SUBJECT: FORWARDS RESPONSES TO FIRST ROUND QUESTIONS ON OL  
 APPLICATION, W/RESPONSES TO PAST DUE QUESTIONS WHICH HAVE NOW  
 BEEN COMPLETED. INFO WILL BE INCORPORATED INTO FSAR AMEND  
 WITHIN FOUR MONTHS.

Subject: WPPSS NUCLEAR PROJECT NO. 2  
RESPONSES TO ROUND ONE  
QUESTIONS - MTEB, CPB, AAB, ETSB, RAB, GSB, HMB

Reference: Letter, S. A. Varga (NRC) to N. Strand (WPPSS),  
"First Round Questions on the WNP-2 OL Application -  
MTEB, CPB, AAB, ETSB, RAB, GSB, HMB,"  
dated December 8, 1978

# HAUFORD 2 BELT LINE MATERIAL IDENTIFICATION.

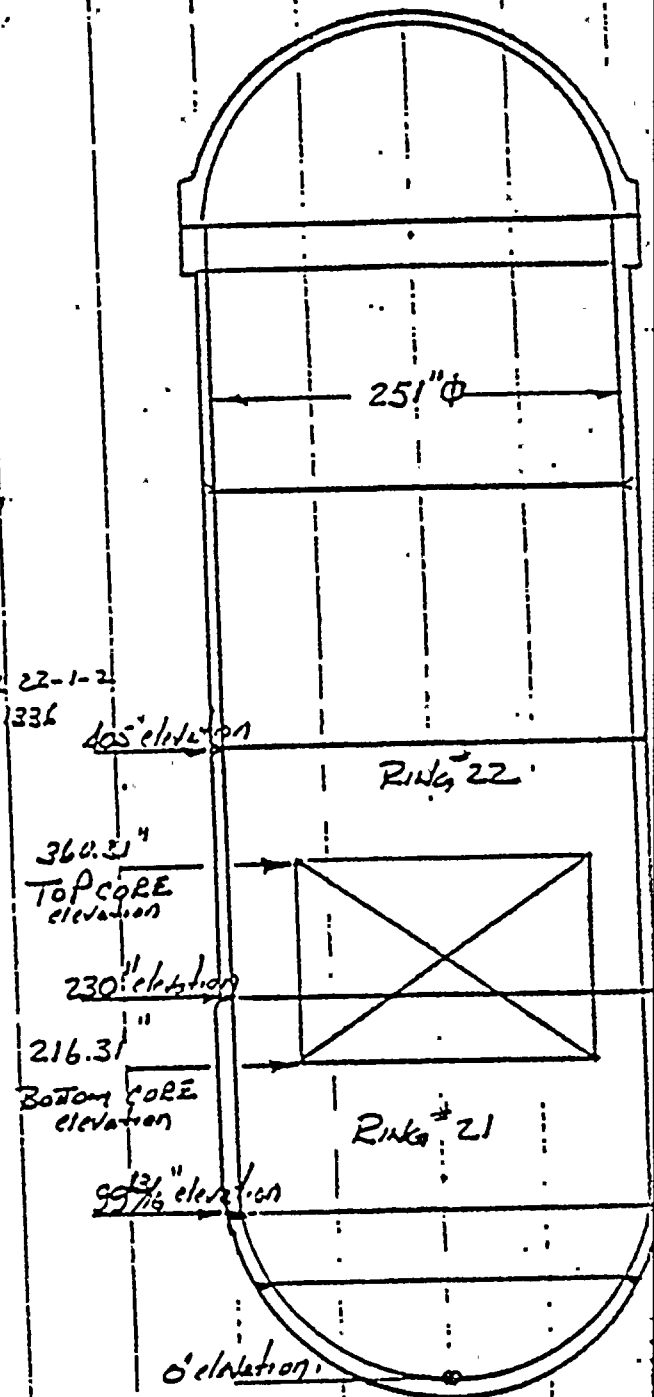
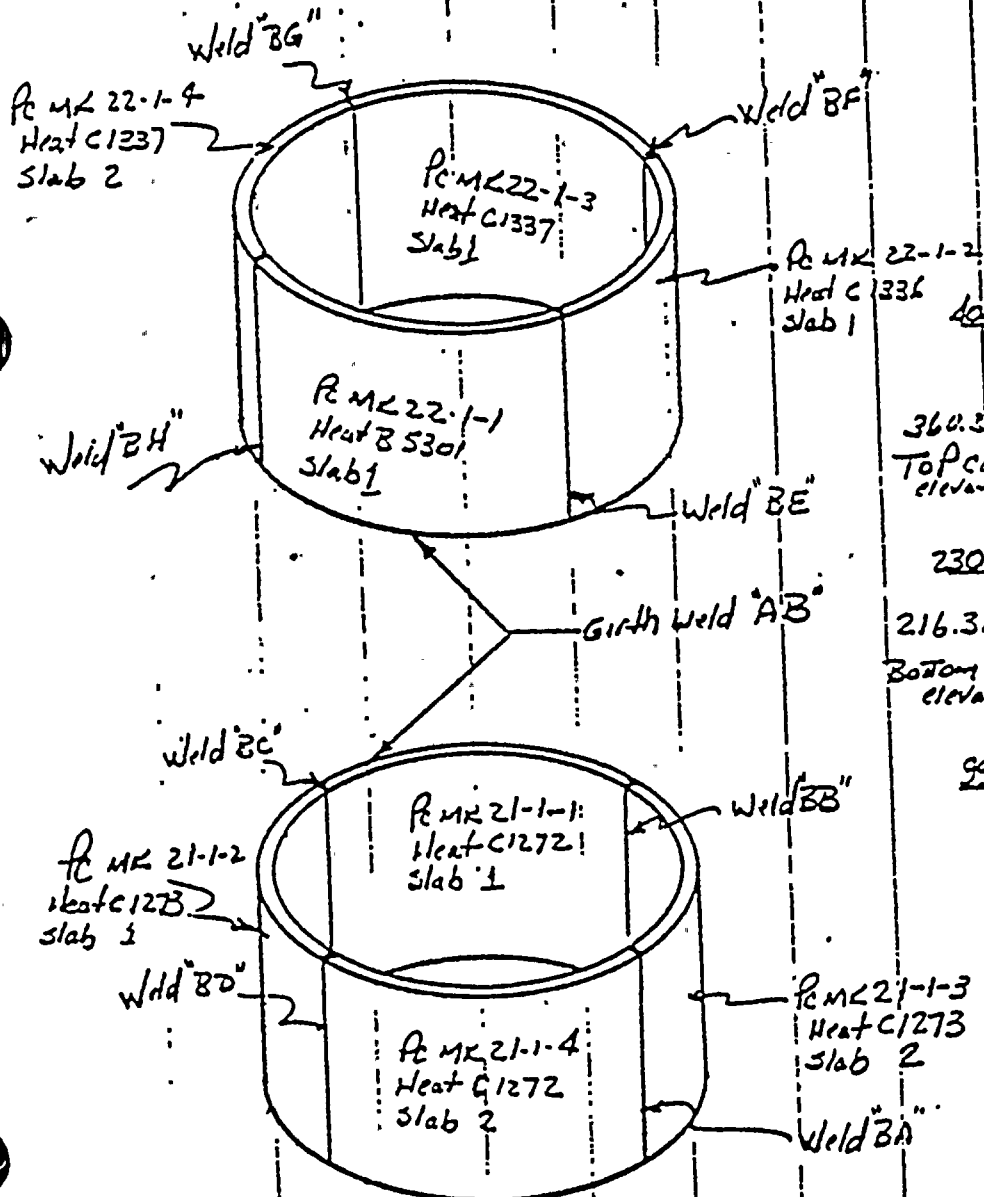
Provide a sketch of the WNP-2 reactor vessel, including the basic dimension, showing all longitudinal and circumferential welds, and all forgings and/or plates. Welds should be identified by a shop control number (such as a procedure qualification number), the heat of the filler metal, the type and batch of the flux, and the welding process. Each forging and/or plate should be identified by a heat number and a material specification.

Figure 5.3-4. WPPSS Hanford Unit 2  
Minimum Temperature Required versus Reactor Pressure

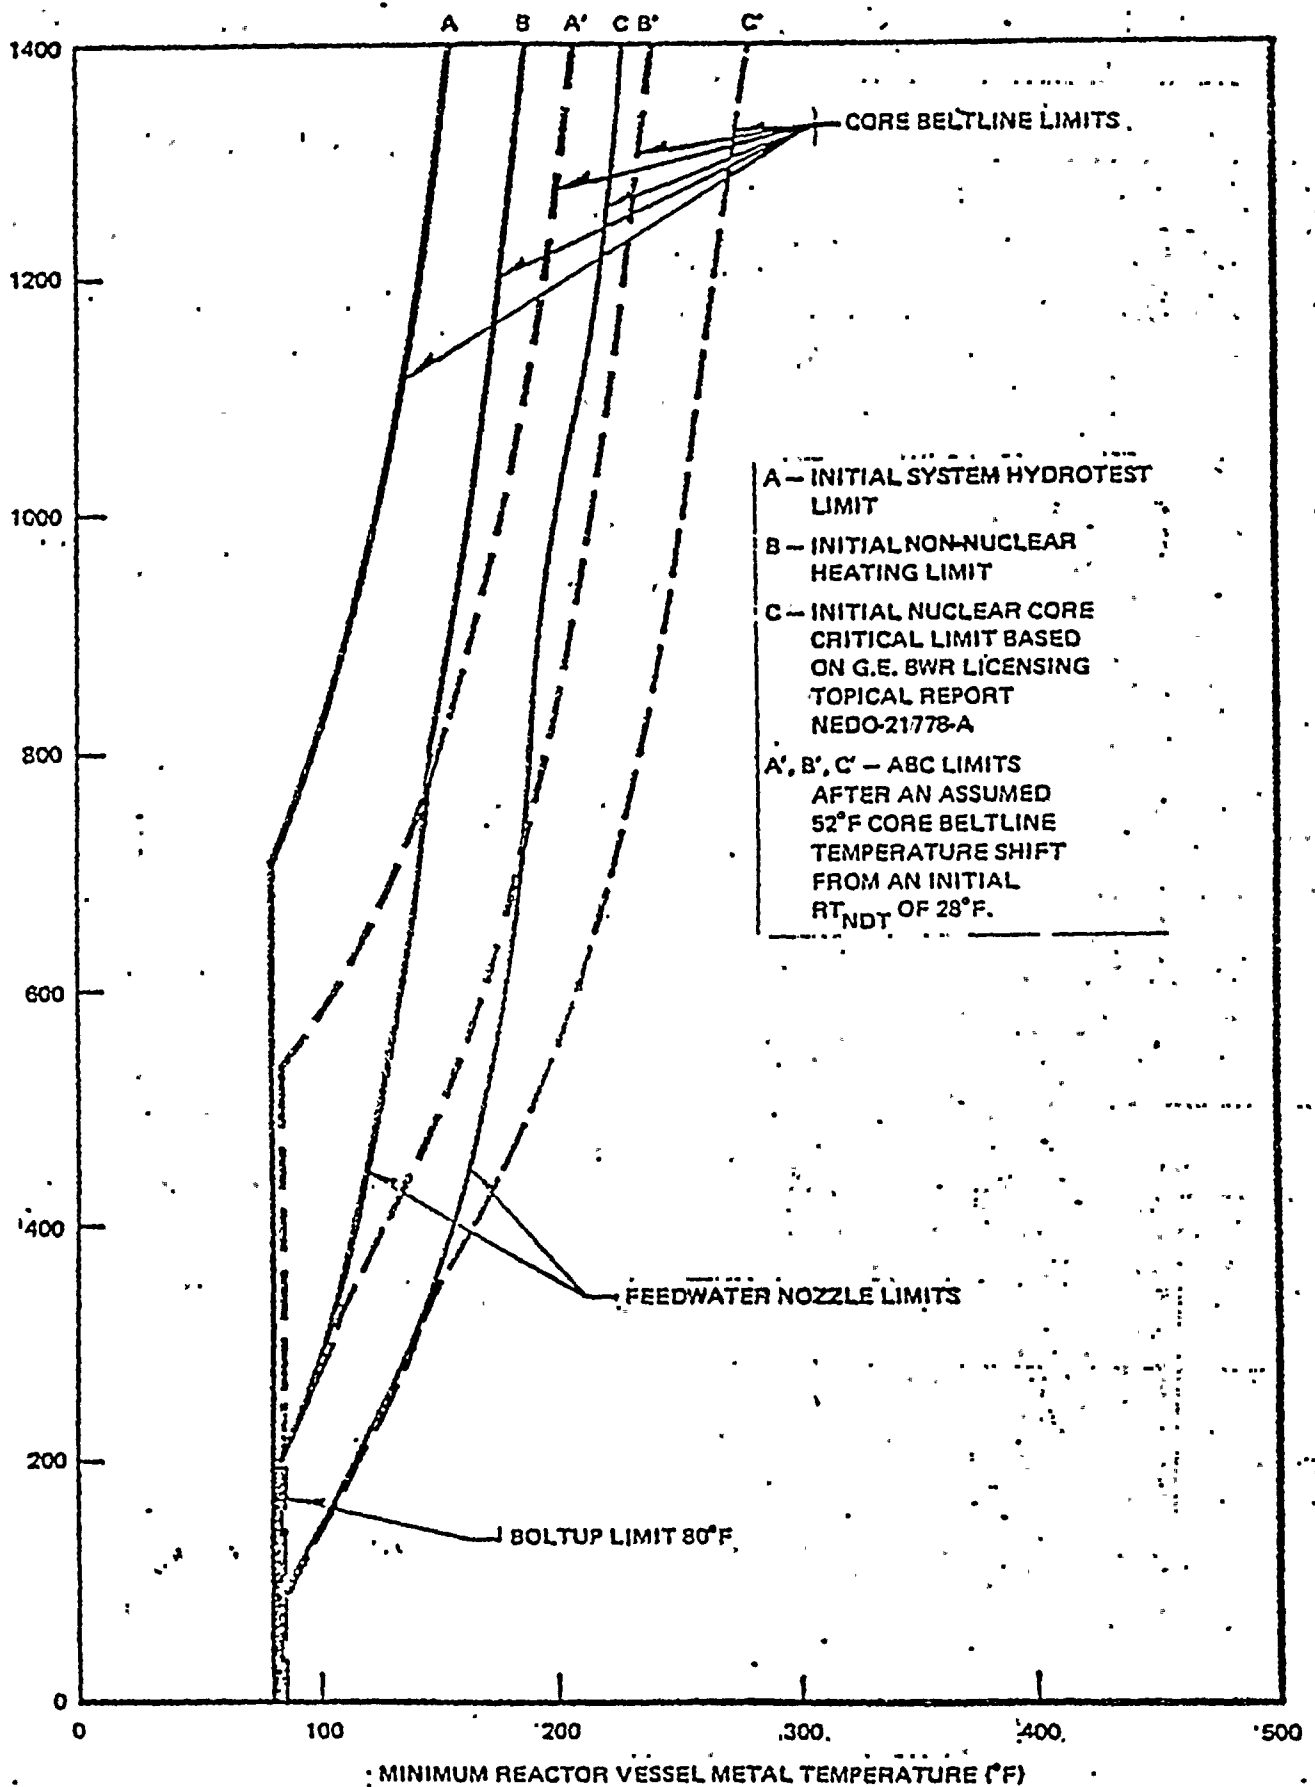
For each of the ferritic materials of the pressure retaining components in the reactor coolant pressure boundary of the WNP-2 plant, supply the following information:

The reactor vessel operating limits are defined by Figure 5.3-4 in the amended WNP-2 FSAR (a copy of Figure 5.3-4 is attached). Curves A, B, and C on Figure 5.3-4 give the limits for beginning-of-life conditions for hydrotest, non-nuclear heating, and nuclear heating. The minimum boltup temperature of 80°F is based on an RT<sub>NDT</sub> of 20°F for a shell plate which connects to the lower flange (Heat and Slab No. C-1307-2). Above 80°F the core beltline plate (Heat and Slab No. C-1272-1), which has an initial RT<sub>NDT</sub> of 28°F, is most limiting for hydrotest (Curve A). The feedwater nozzles, which have an RT<sub>NDT</sub> of -14°F, are more restrictive than the core beltline at lower pressures during non-nuclear and nuclear heating (Curves B & C).

FIGURE  
2.4-9

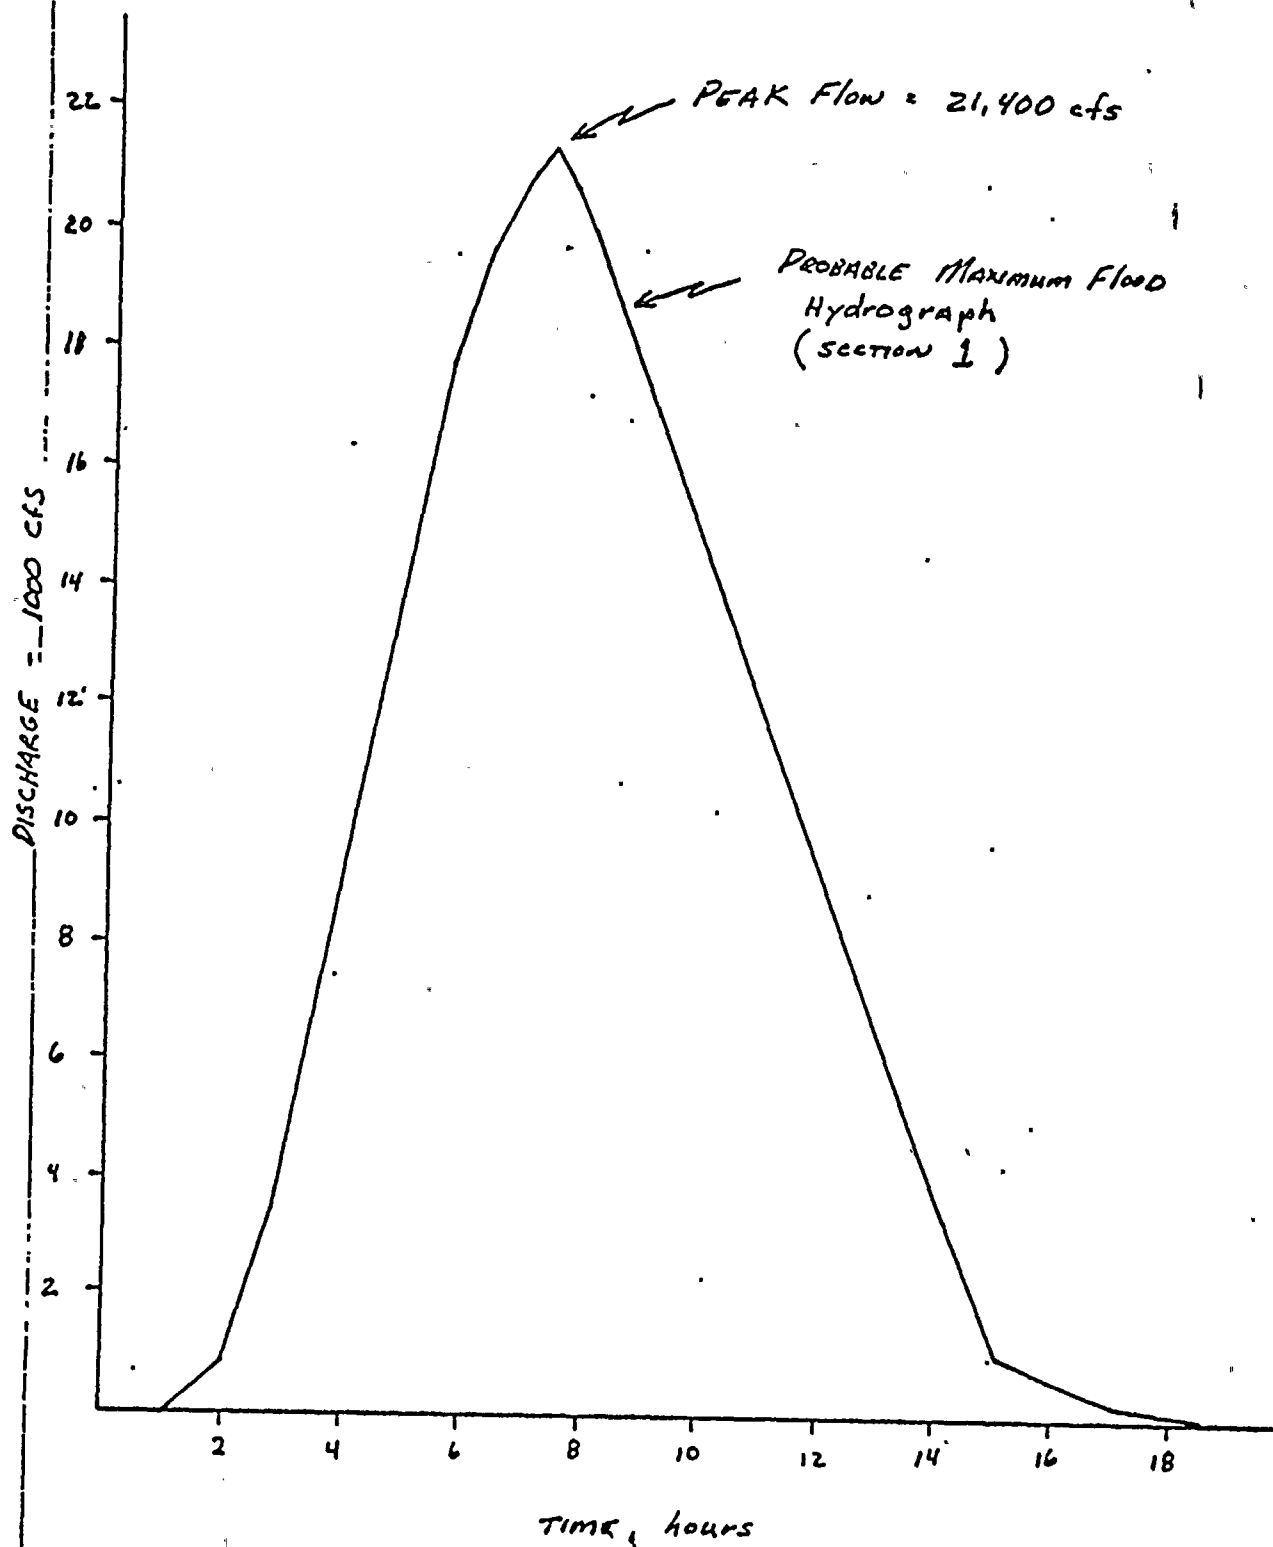
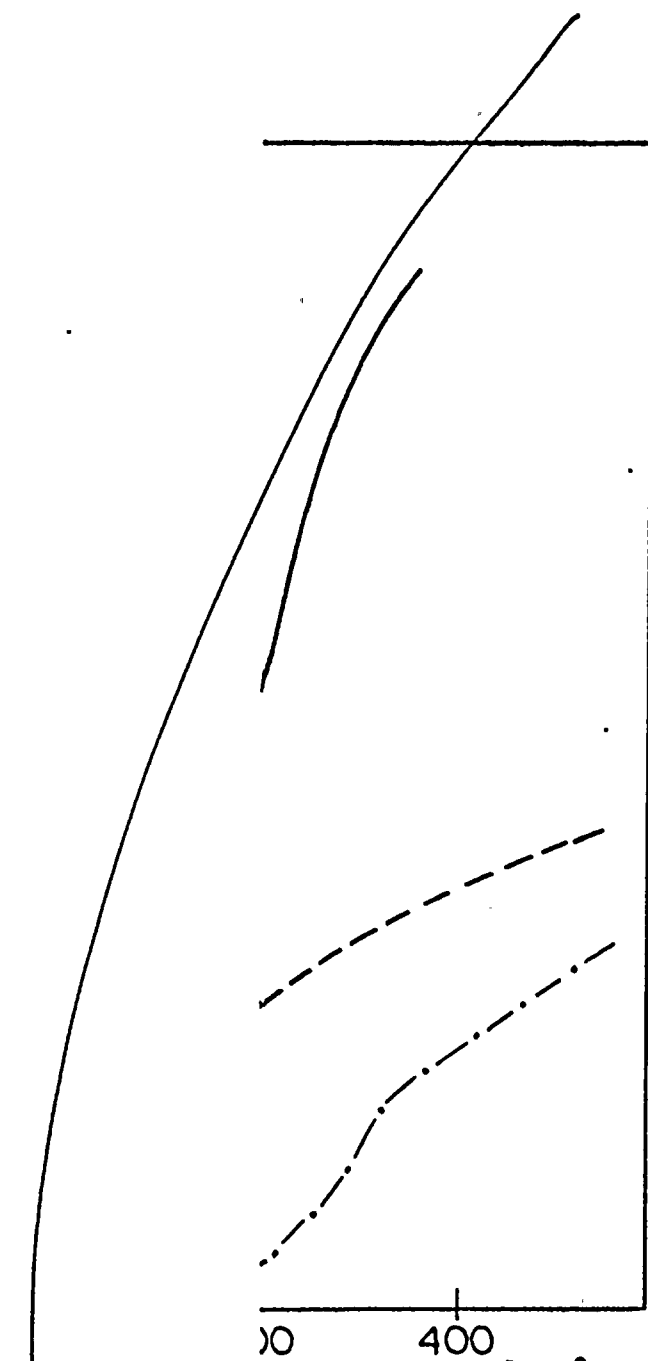
replace  
with figure  
attached

The PMF runoff hydrograph produced by the PMP at cross-section 1 (Figure 2.4-10) is shown in Figure 2.4-9. The peak discharge at this location is 21,400 cfs.

FIGURE  
2.4-<sup>10</sup>/<sub>8</sub>

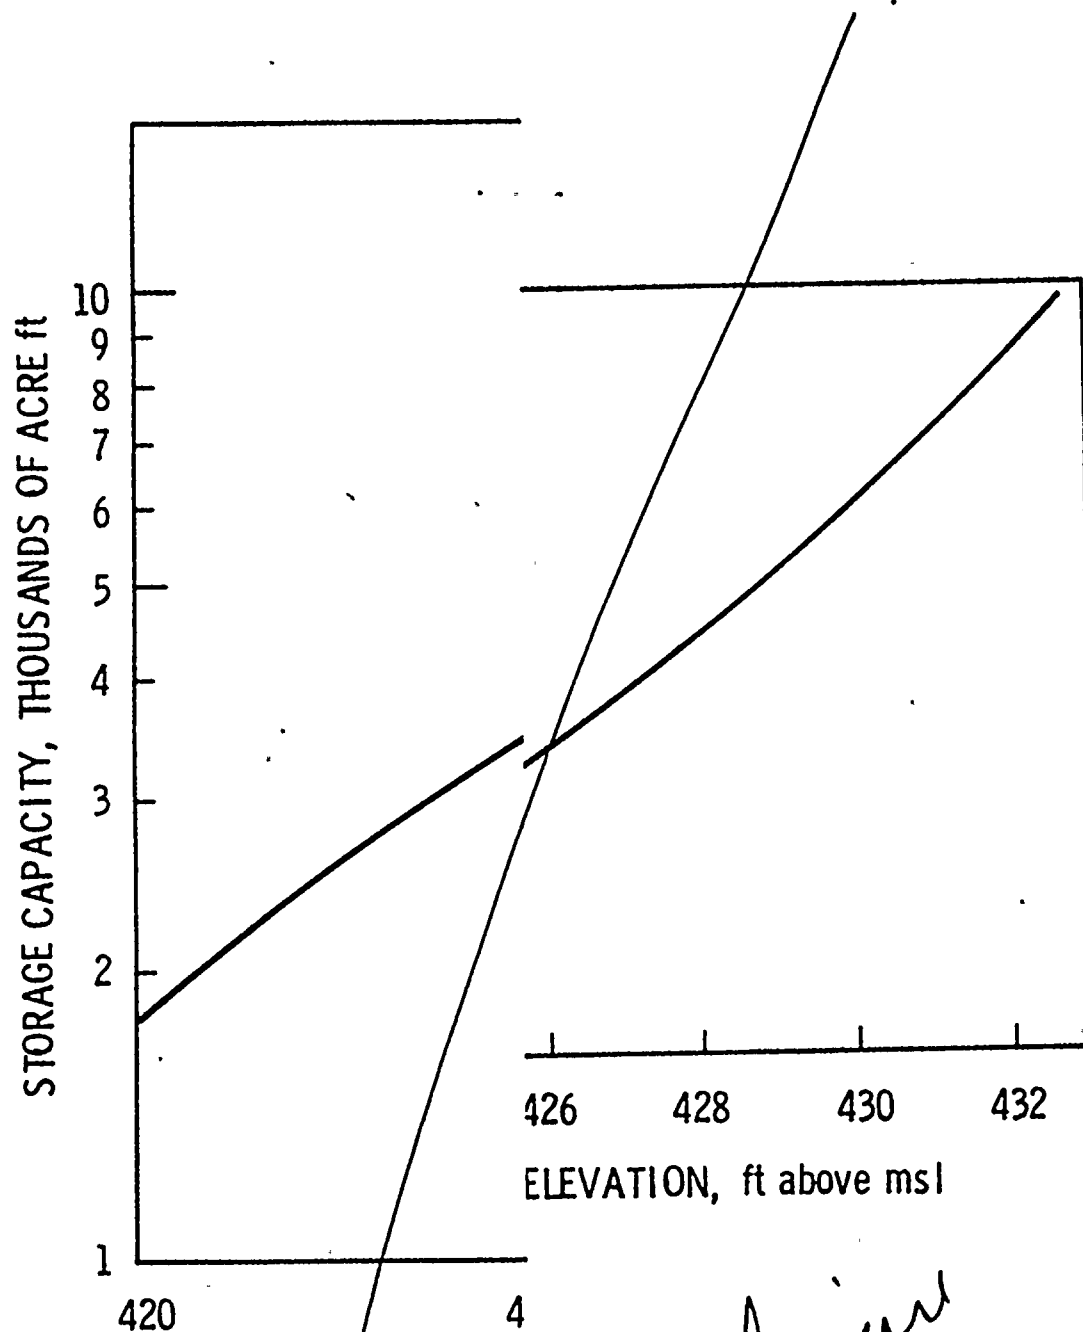
*replace figure with attached*

Using the computational procedure of Reference 2.4-52, it was determined that the channel restrictions at cross-sections 5 and 7 (Figure 2.4-10) do not control the flow. The still-water elevation at the plant site (cross-section 8) was determined to be 431.1 ft. MSL. *The water surface profile is shown in Figure 2.4-12*

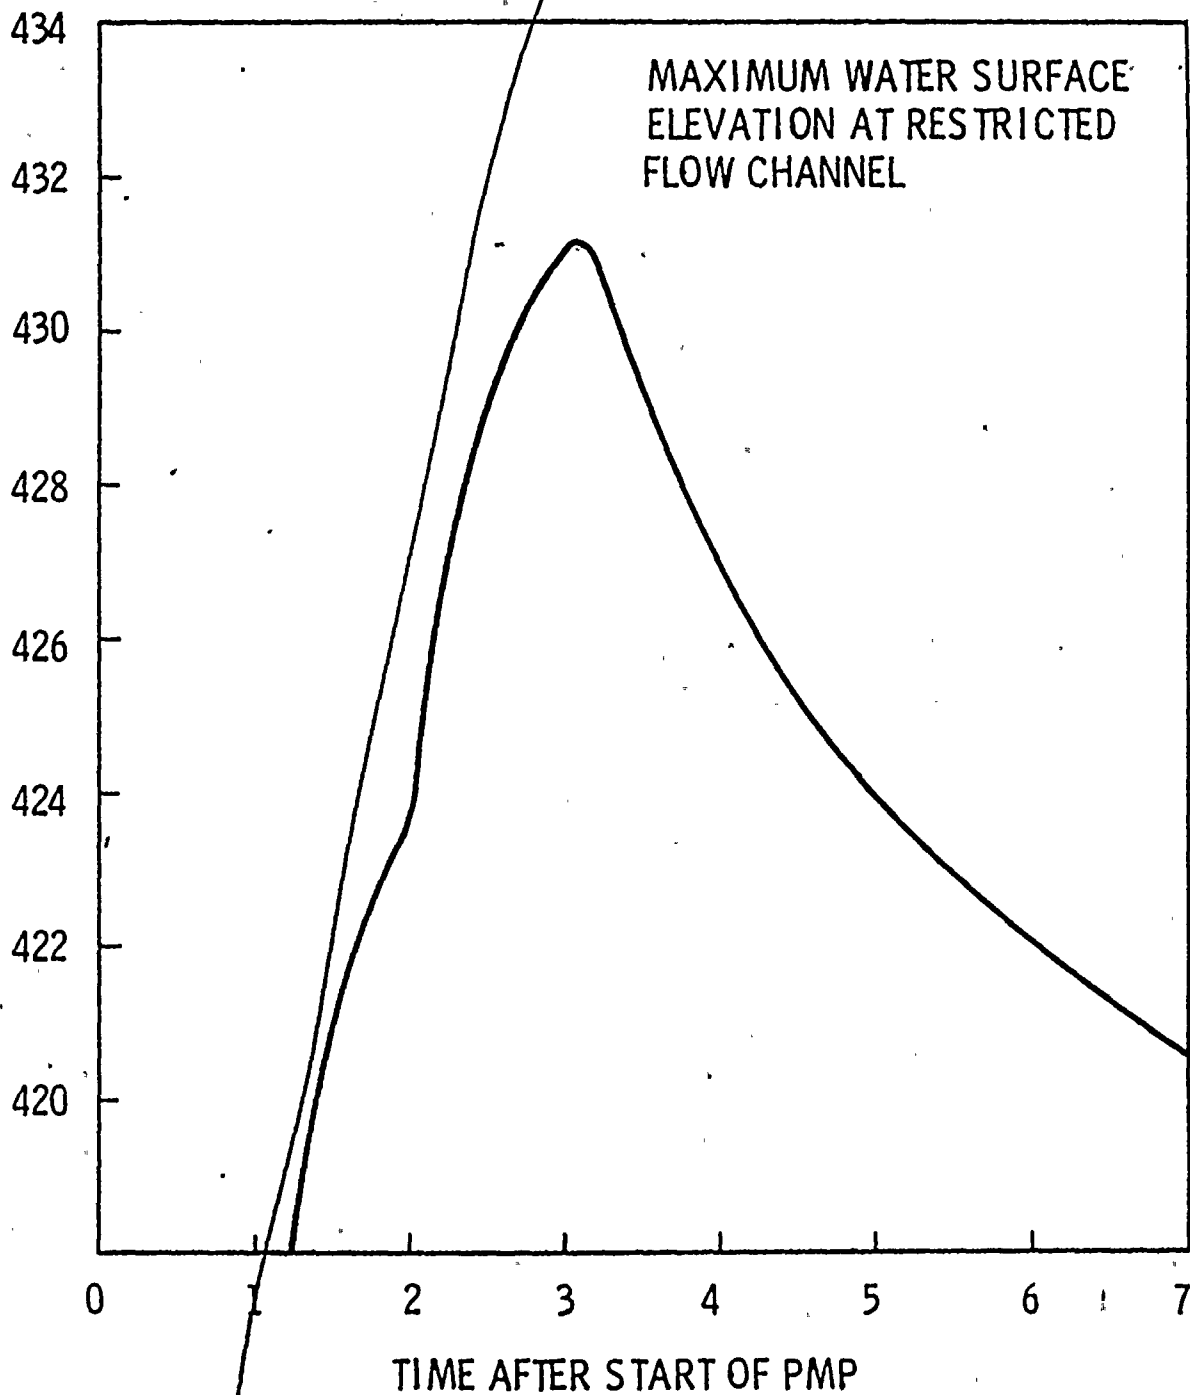
*replace figure with attached*
